**MEMORANDUM**

**FROM: Michael Stevens, Integrys Energy**

**SUBJECT: Integrys Energy – Response to Redline ICAP Manual 7-30-2009 in regards to  
SCR**

**DATE: August 11, 2009**

Freezer Facility Monthly Demand (Resource ID: 1311061)

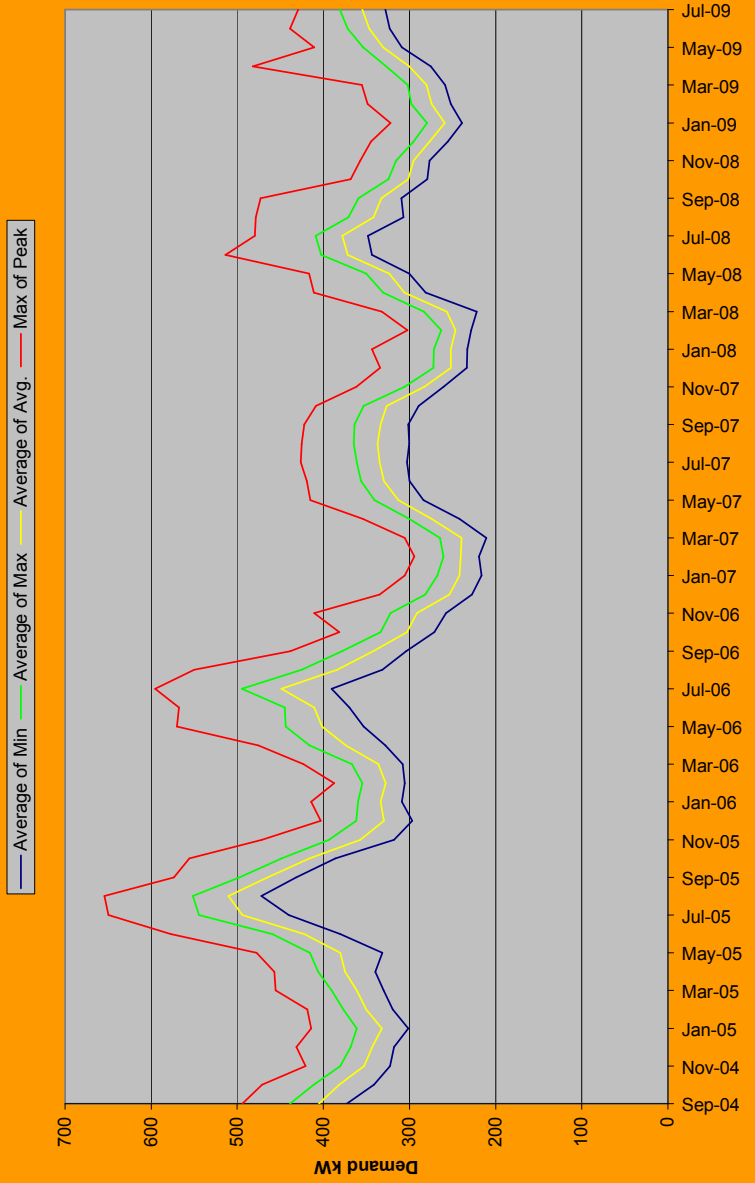
**5. Weather Affects on APMD:** NYISO’s recent concerns regarding long-term shutdowns are heavily influenced by the recent downturn of the economy. However, it must be noted that comparing recent demand data to an APMD established a year prior fails to account for the impact of localized climate trends. Peak loads for buildings with large building envelopes are heavily biased by the use of air conditioners to cool workspace, etc. Economies aside, NYISO would have observed an overall reduction in demand this summer (2009) from previous years solely based on a decrease in temperatures. To help illustrate this example, it can be seen from the below change of average temperature (source of data from Energycast PowerTrader) that average temperatures for July were down 4.5 degrees (71.4 – 66.89) or 6.3% from the previous year. Further, average temperatures for July are down 8 degrees (74.94 – 66.89) or 9% from 2005. As such, NYISO should account for the affects of weather and temperature on loads when determining how much (as a %) a Resource’s demand has change from one year to the next. To understand the impact temperature has on a Resource’s APMD NYISO can refer to the following 3 examples that include:

- (1) A freezer facility’s monthly peak demand (Resource ID: 1311061)
- (2) A State facility’s monthly peak demand (Resource ID: 1511059)
- (3) A stone quarry’s monthly peak demand (Resource ID: 1611154)

In these 3 examples it can be clearly seen that temperature is directly correlated with the peak demands of Resources that have large HVAC (State Facility) loads and large chiller (freezer facility) loads. These loads are heavily influenced by ambient temperatures. On the other hand stone quarries are not heavily influenced by temperature at all and therefore maintain consistent demand regardless of weather.
